Comments on the Draft Report „A Structural Reevaluation of the Collapse of World Trade Center 7“ (JL Hulseley et al, September 2019)

Prepared by:
[Oystein]

Figure 2.5 Progressive collapse separated into two parts.

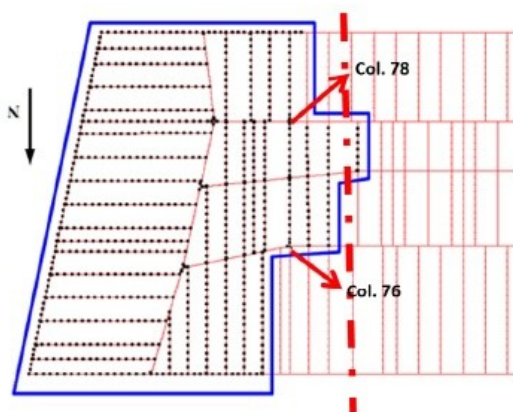
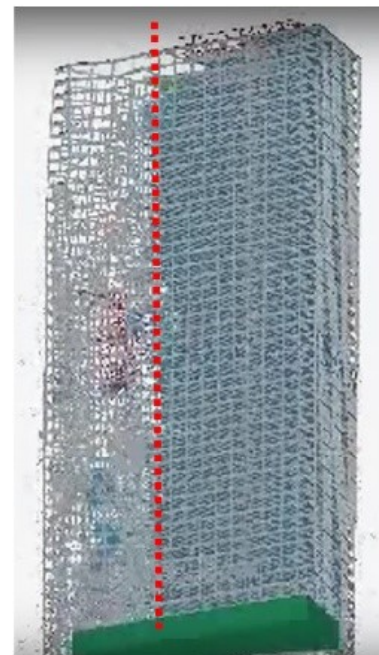
In the next paragraph (page 29), Hulseley go too far in conflating the ANSYS (NCSTAR 1-9 Chapter 11) and LS-DYNA (NCSTAR 1-9 Chapter 12) models:

„The NIST simulation of the collapse illustrated that the west side of the building acted differently from the east side. The structural response to failure would more closely resemble the actual collapse if the connections had been accounted for throughout the structural frame. By not modeling the connection failures outside the selected area shown in Figure 2.4 above, NIST appears to have reduced the stiffness in the area outside the selected area and separated its progressive collapse simulation into two parts (see Figure 2.5).“

Figure 2.5 juxtaposes two different models:

The floor connections east and west are modeled differently only in the ANSYS model (left), not in the LS-DYNA model (right)! It seems reasonable that, in the right image, the east part looks less

stable because it is *already* collapsing! NIST concentrated on the east part of the building, and modeled it somewhat more sophisticatedly, because the real WTC7 was observed to collapse in its east part first. So the causation is that the ANSYS model has the blue area because that's what collapsed first (became unstable; lost stiffness) first, and not: The LS-DYNA model looks unstable in the east because of the blue area.

In addition: It may be true that some connections west of columns 76-78 would have been detected as failed had the ANSYS model included break elements there, and these failed connections would have been transferred to the LS-DYNA model as starting conditions, making the west core somewhat less stiff. However (NCSTAR 1-9 page 539, my emphasis):

So in short: The LS-DYNA model, being fed with the „Case B at 4 h“ structural temperatures throughout the entire floors 7 to 14, was able to model the connection damages that arose from those temperatures at that time and proceed from there. It is not true that this model had to do entirely without fire damage west of the blue area.
